ORIGINATION FORM

Proposed Revisions to a Standard Plans Index
(Please provide all information — Incomplete forms will be returned)

Index Number: 659-010
Sheet Number (s): 1 of 1
Index Title: Span Wire Mounted Sign Details

LAST REVISION 11/01/18	11/01/21	DESCRIPTION:	 FY 2021-22 STANDARD PLANS	SPAN WIRE MOUNTED SIGN DETAILS	INDEX 659-010	SHEET 1 of 1
--------------------------------------	----------	--------------	----------------------------------	--------------------------------	------------------	-----------------

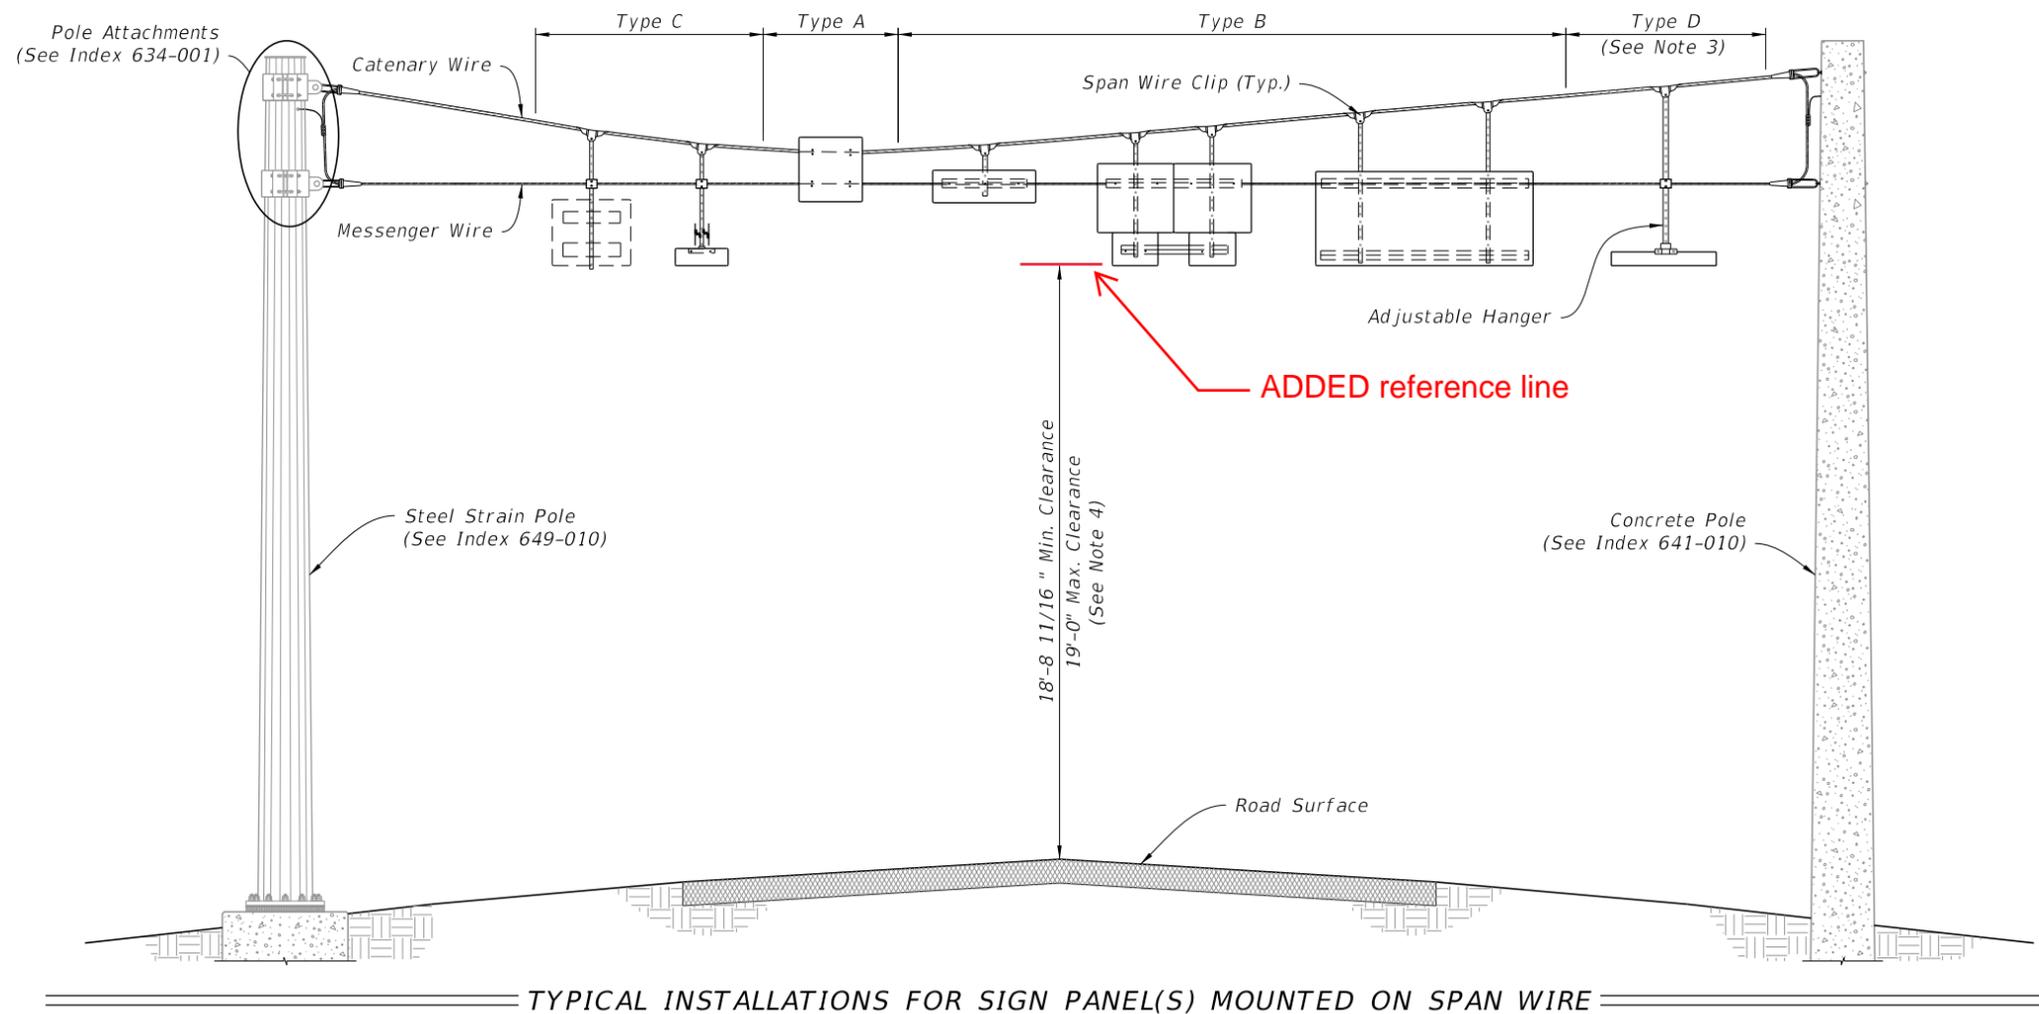
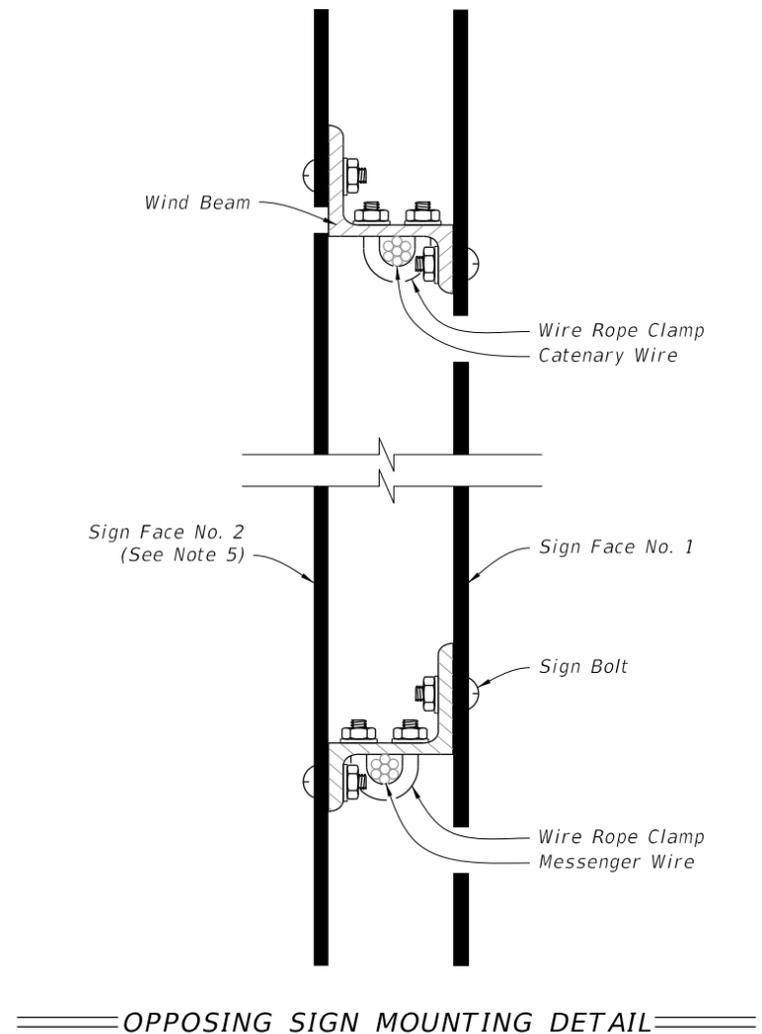
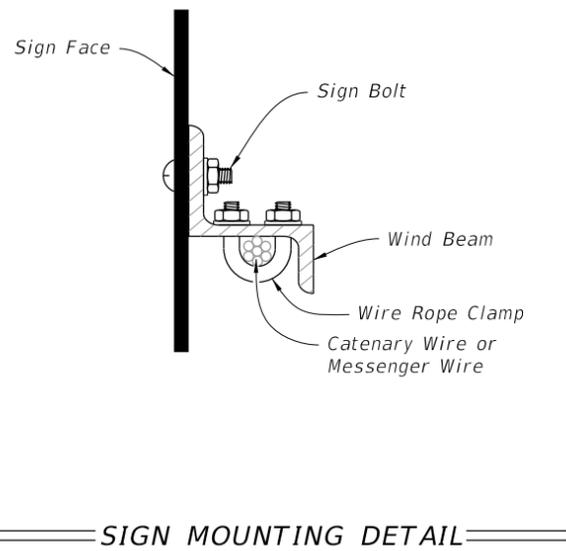
Changed Note 2.B.b. update width to greater than or equal to 8'.

CHANGED TO: 8'-0"

This is a corrective revision to match FTP-31-06 and FTP-32-06 shown in SP Index 700-102
